Architectural Review Board Staff Report

Project Type: Amended Architectural Elevations

Description: **Larry Enterprises – Lynch Hummer, Lot B (Scott Retail):** Amended Architectural Elevations and an Amended Architect's Statement of Design for a 7.09 acre lot of land zoned "PI" Planned Industrial District located on the west side of Boone's Crossing on the north side of North Outer 40 Road.

Scott Retail Approved Elevation

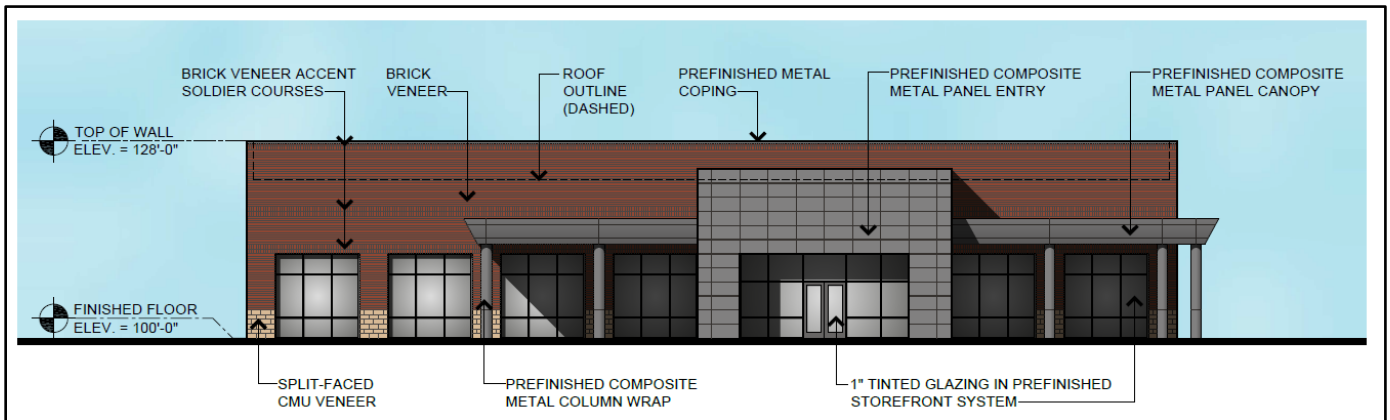
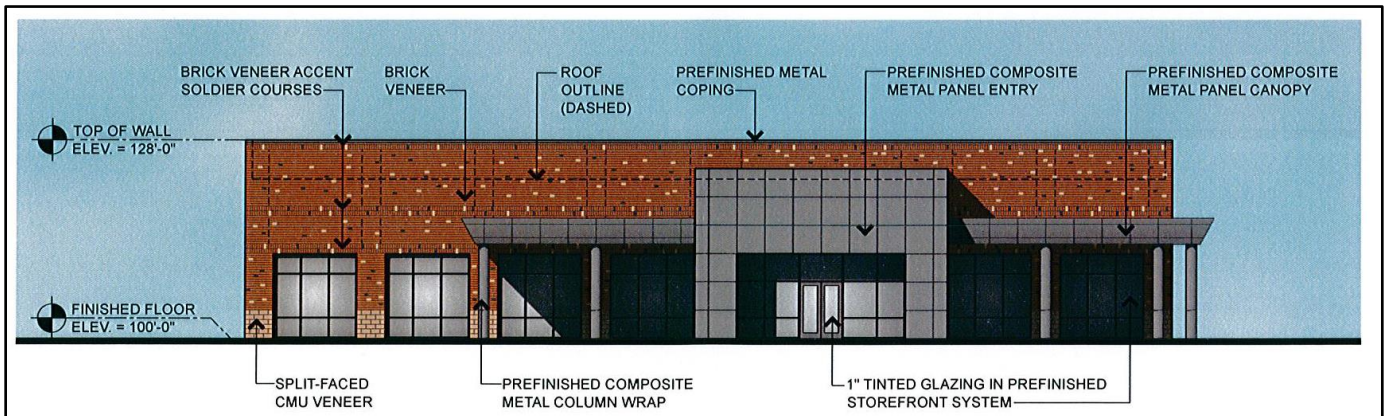
After this project was presented to the Planning Commission, the protective coating on the composite metal panels on the front façade of the building was removed. At that time, Staff noticed that the metal panels appeared darker in color than anticipated based on the approved elevations. This concern was immediately brought to the attention of the applicant and information regarding this is included in the applicant’s submittal. Below is a comparison of the original approved architectural elevation and the proposed elevation showing the brick as constructed.

As shown above, the approved brick from the original elevation was a solid, red brick. The brick in the proposed elevation, which was used on the actual building, is predominately red in color, with lighter and darker accent bricks. Further, the composite metal panels appear to be a lighter, steel gray versus the dark, slate gray that they appear to be, especially when viewed from a distance. On the following page are photos of the Scott Retail building and the adjacent Lynch Hummer building.

Composite Panels (Exhibit B):

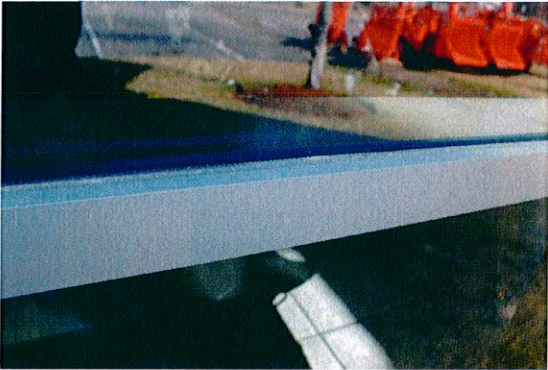
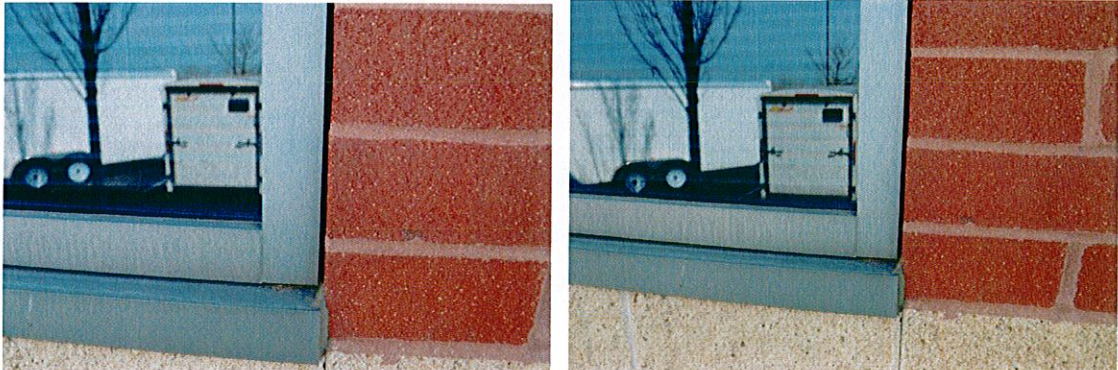
Staff is also requesting that the Architectural Review Board review the composite metal panels to ensure compliance with the approved Architectural Elevations. As shown in both the Staff photos in this report and the photos contained in the applicant's submittal, the appearance and color tone of these panels changes depending on the weather and other conditions.

As you can see in the pictures, the panels do take on a lighter or darker color, depending on how the light hits them and the distance you are standing away from them. From what I can tell, the storefront system on the new building does closely match the storefront system on the former Lynch Hummer building. The composite panels on the front of the new building were fabricated to match the storefront system as shown in the pictures.

Add evergreen landscaped island between buildings (Exhibit E):

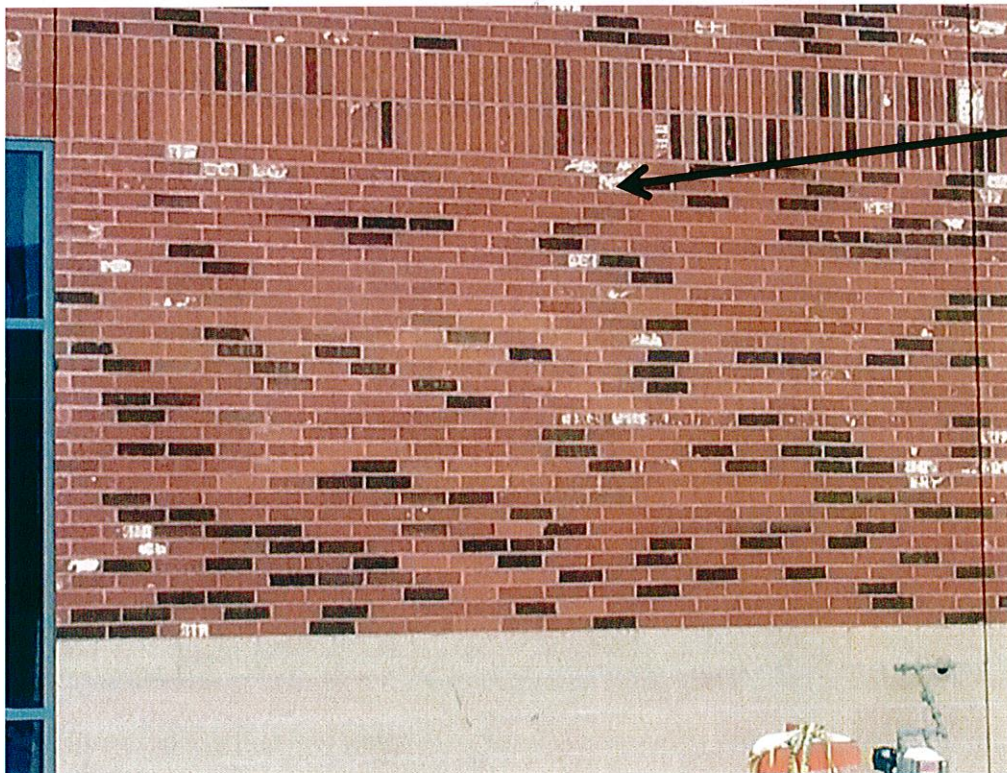
Option 2: Leave building as is and plant a thick evergreen island on the east side of the new building, creating a line of separation and an additional landscape screen similar to the buffer between Junior Achievement and the former Lynch Hummer Building (see exhibit E). The parking along this side of the building would not be needed as there is adequate parking in front and a very large lot in the rear of the building.

Stain Tan/Lighter bricks to blend (Exhibit F):

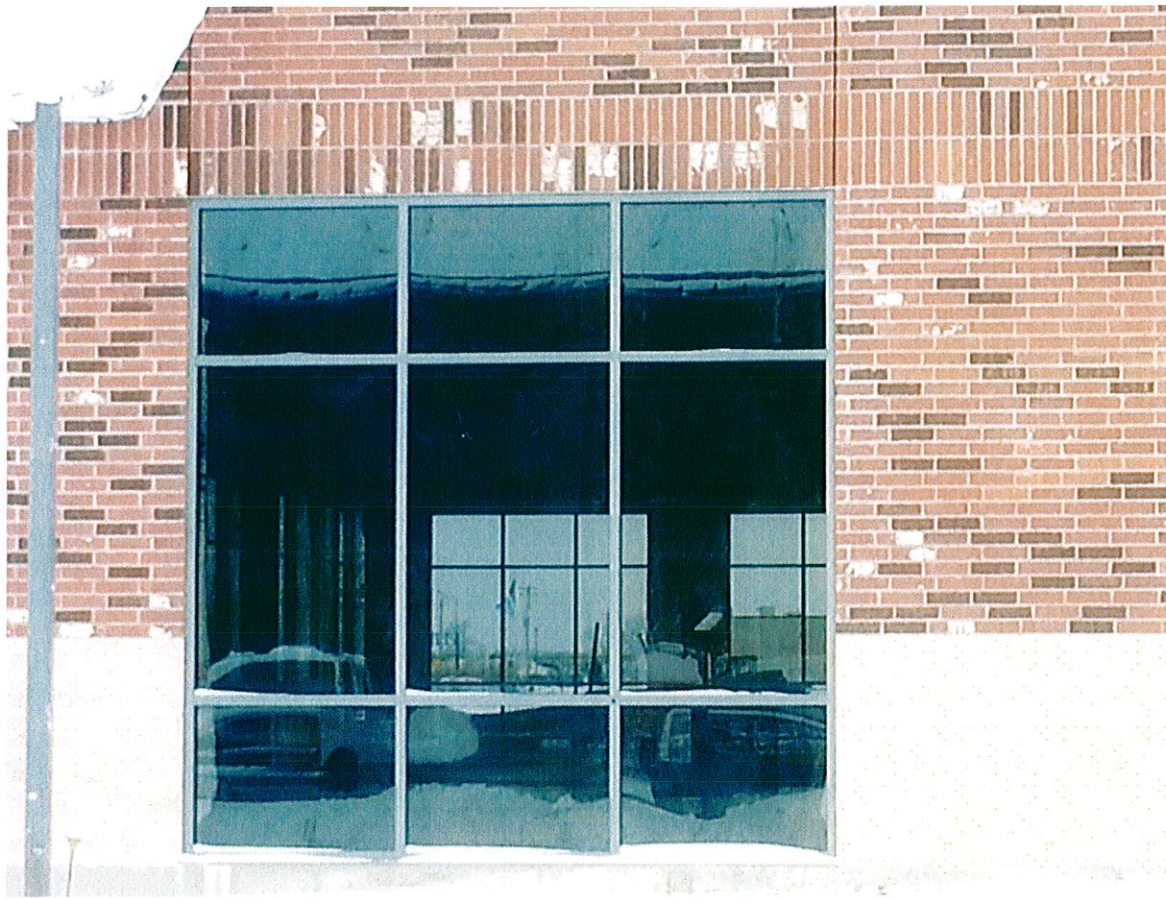
Option 3: Stain the lighter color bricks darker to blend better with the existing bricks (see exhibit F).

Lighter Tan bricks could be stained/darkened to blend better

NORTH ELEVATION

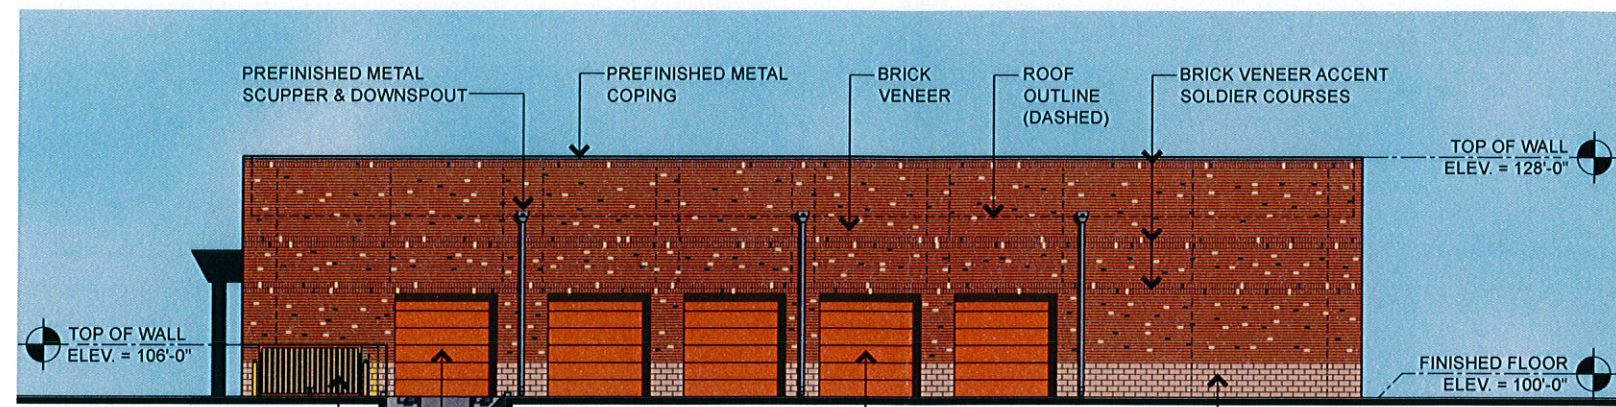
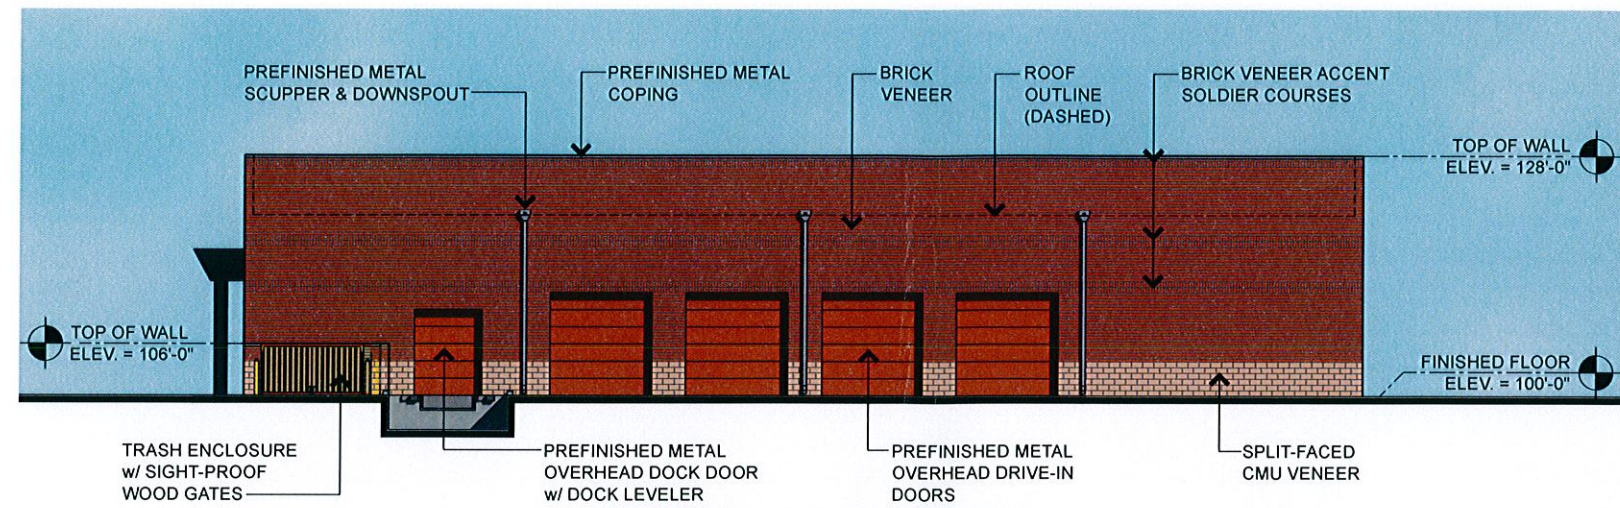
In addition to the items discussed above, there is one other minor deviation from the approved architectural elevations. On the rear elevation, the approved architectural elevation shows four drive-in overhead doors and one smaller dock door with a leveler. On the actual building and included in the proposed revised architectural elevation, all five overhead doors are the same size.
